# PROPOSAL REQUEST 05

Wichita Biomedical Center

Issue Date: 6.29.25

1. See attached Drawings with revisions clouded and labeled PR 05 Exterior Signage.

EXTERIOR SIGNAGE  
DETAILS

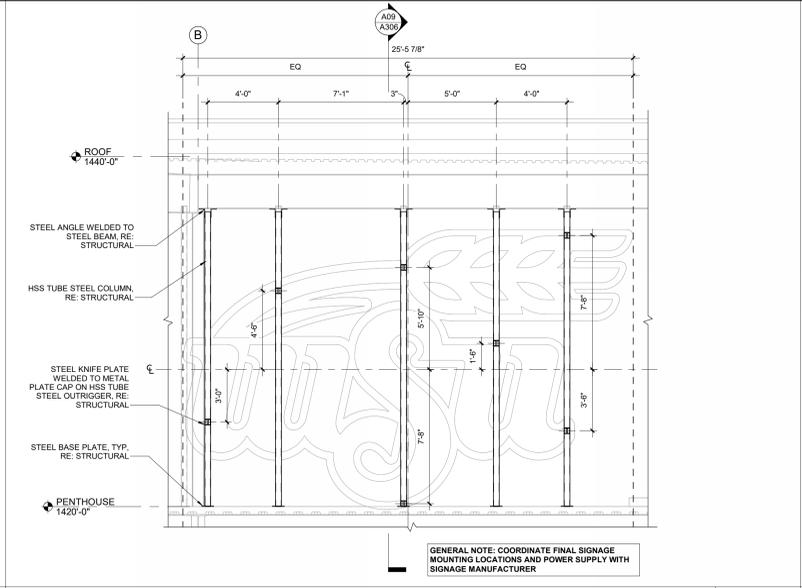
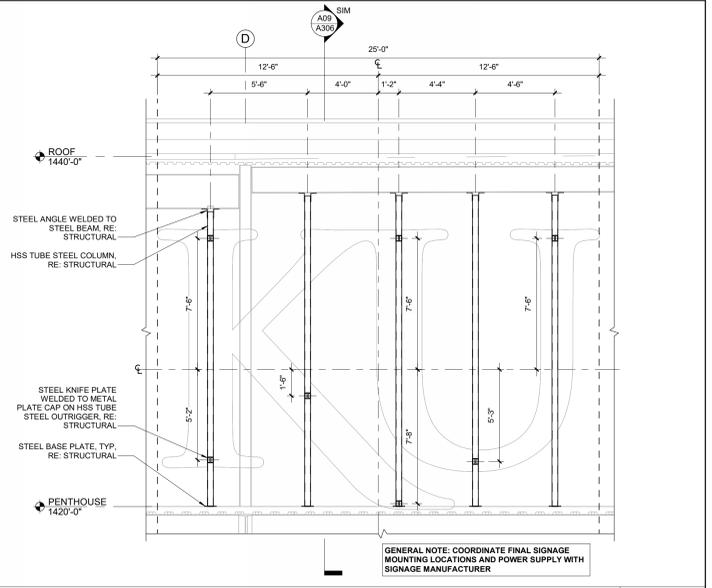
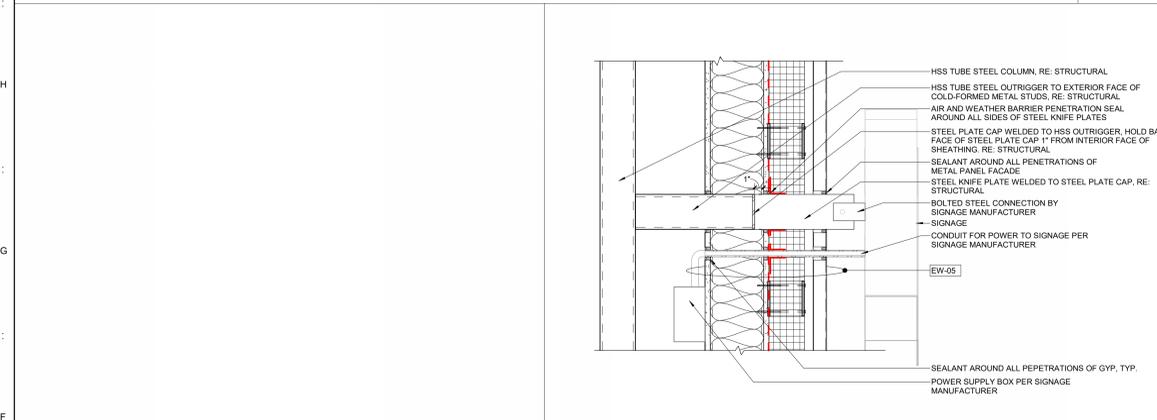
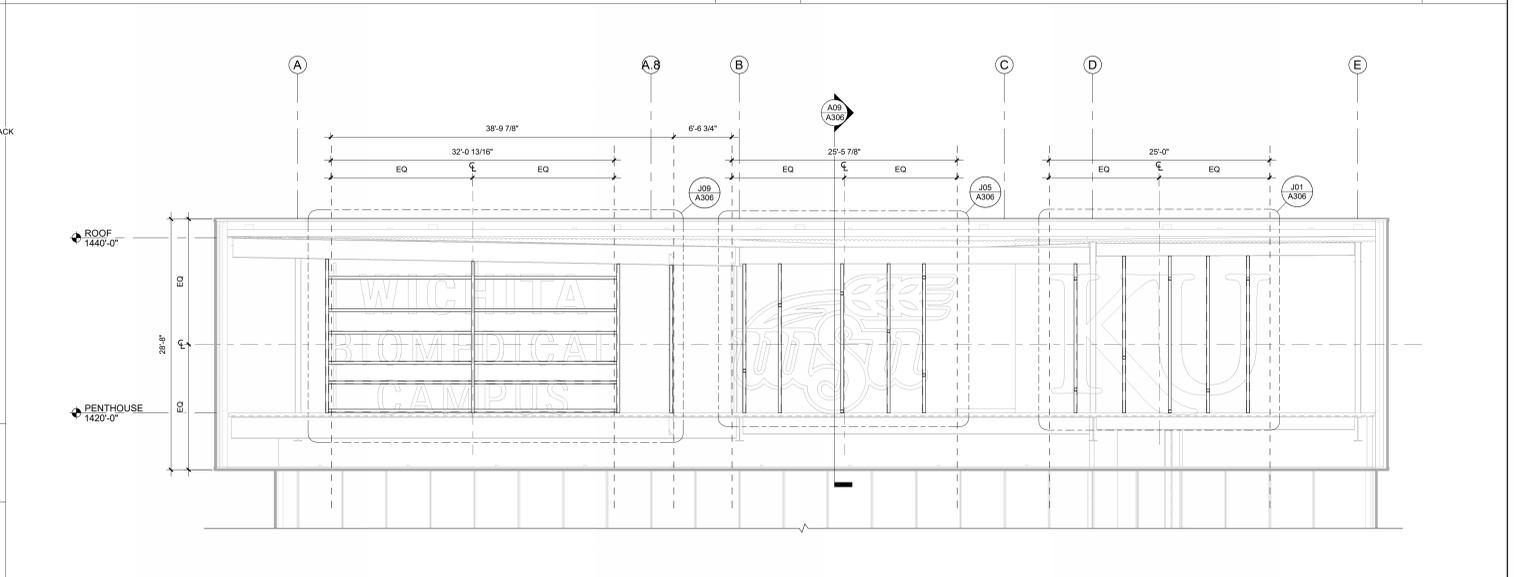
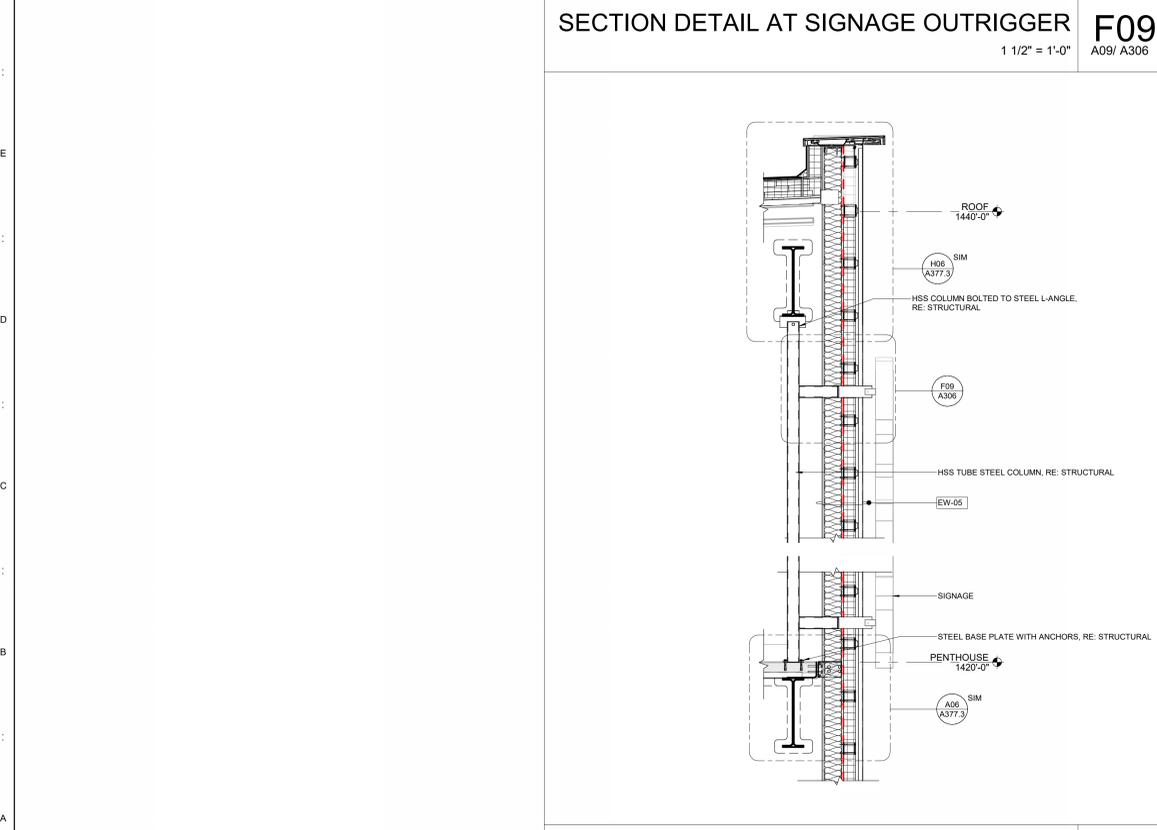
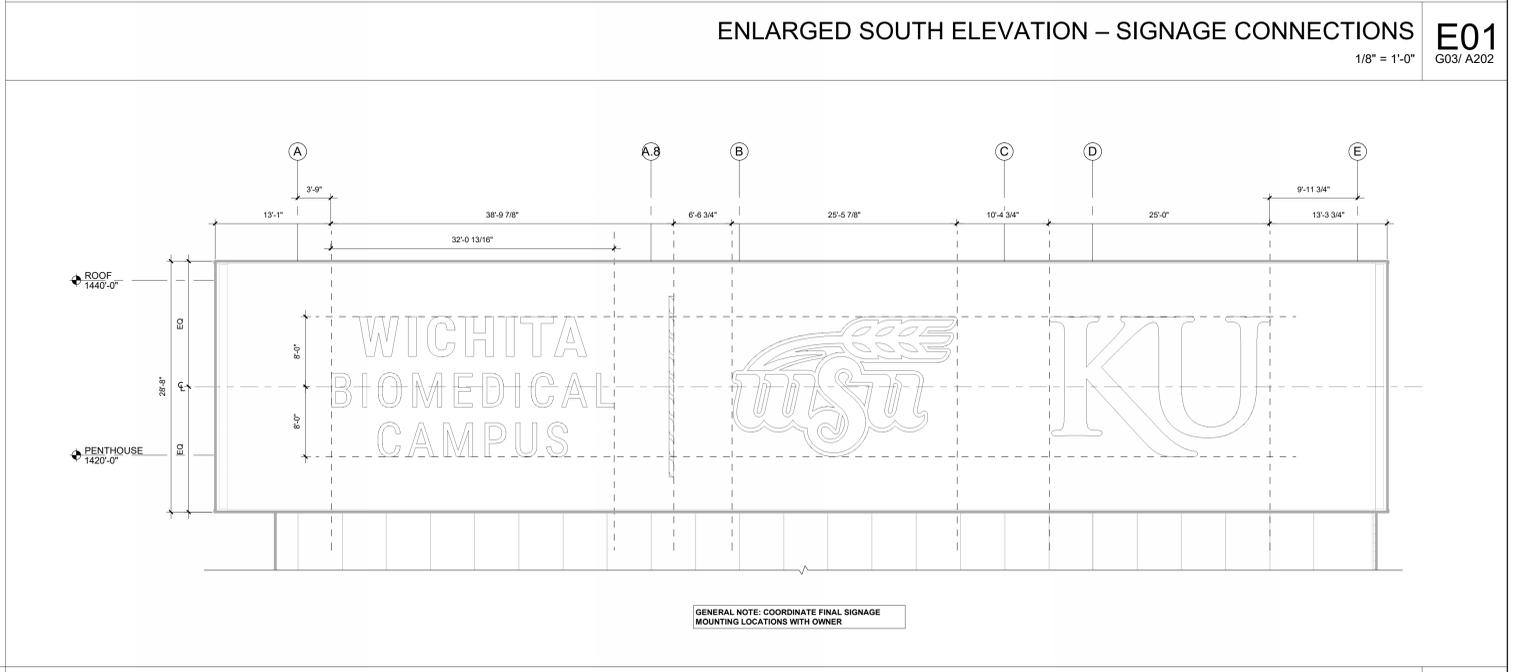
1. See attached Drawings with revisions clouded and labeled PR 05 Exterior Signage.
